An Coimisiún Pleanála
64 Marlborough Street
Dublin 1, D01 V902

Re: Formal Submission to Planning Application PAX91.323780 — Ballinlee Wind Farm (17 turbines, 110kV substation and ancillary works)

From: Janet Power, New Deerpark, Bunclody, Enniscorthy, Co.Wexford, Y21 V4HE

Date: 18 November 2025

Figure 4-12: Map of the aggregate and concrete quarries

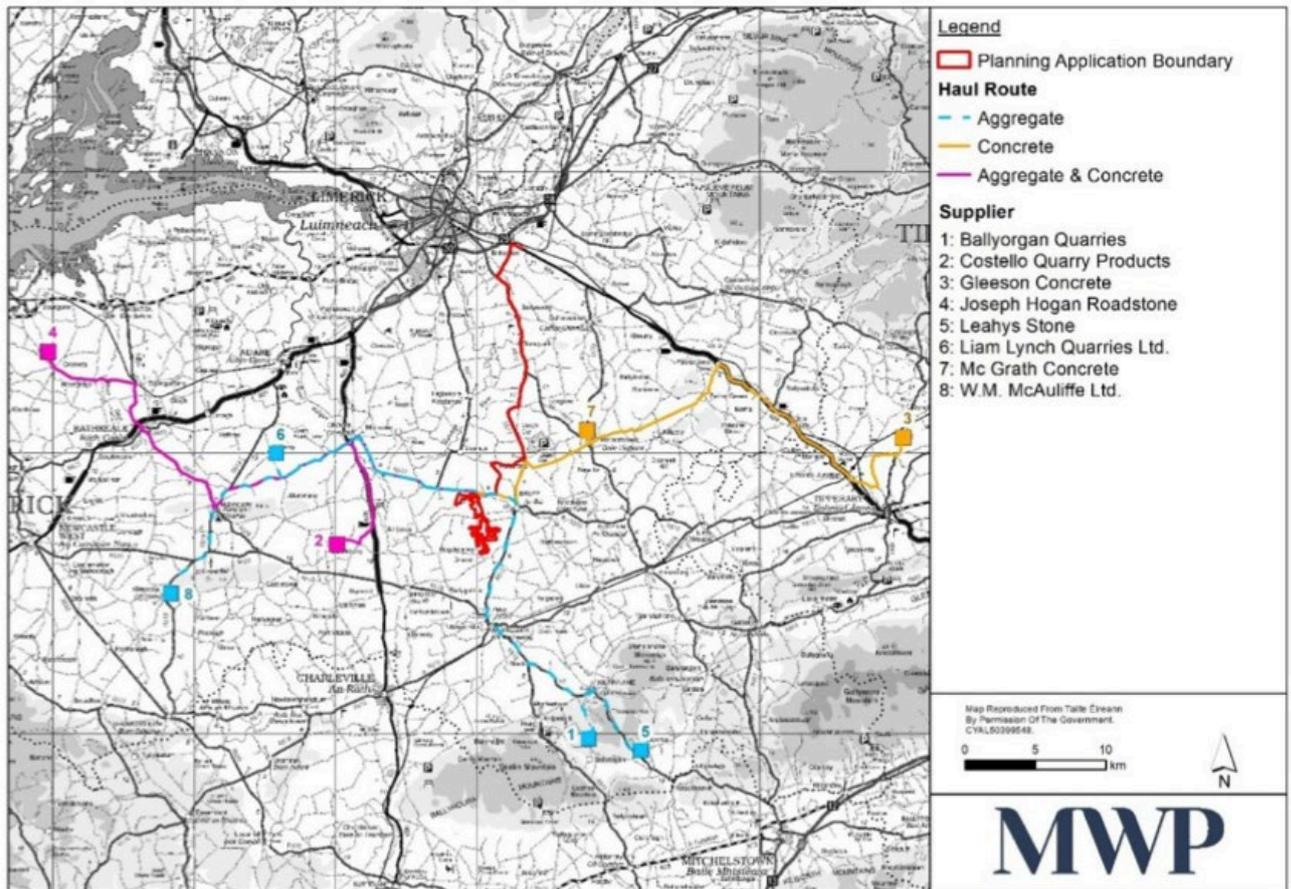
More than 50 percent of this traffic will pass my property - that includes the entirety of the concrete trucks and up to half of the aggregate; reference *Chapter 4: Civil Engineering Figure 4-12: Map of the aggregate and concrete quarries*

Chapter 4: Civil Engineering Figure 4-12: Map of the aggregate and concrete quarries illustrates that approximately half of the aggregate and all of the concrete haulage will be pass along the R516 passing The Orchard directly. This relates to
